MEMORANDUM

Our Ref: EP/DC/P/2019/0246

Location: O. S Grid Ref: 377 573 Gamford House, Gamford Lane, Rossett, Wrexham.

Development: Change of use, conversion and replacement agricultural barns and farmhouse to form 8 no. detached dwelling houses including removal of derelict structures across the site.

7.5t Panel Van
 Overall Length
 Overall Width
 Overall Body Height
 Min Body Ground Clearance
 Track Width
 Lock to Lock Time
 Kerb to Kerb Turning Radius

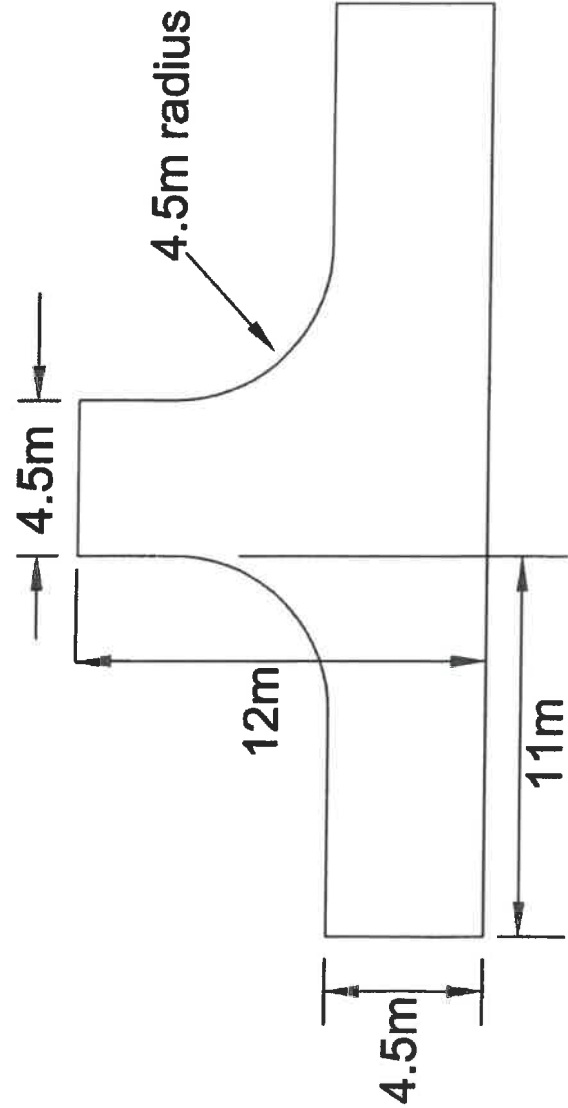
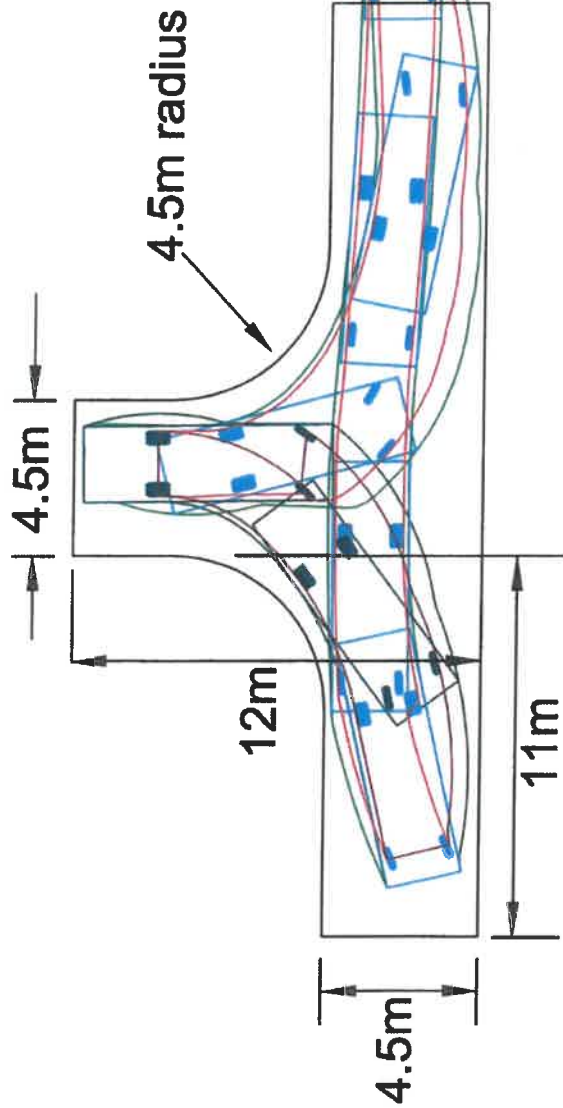
I would recommend that a suitable turning head is provided to accommodate the turning movements of a medium sized delivery vehicle (see attached detail). The proposed turning area is considered inadequate. **Could you please ask the applicant to indicate this detail on a revised layout plan.**
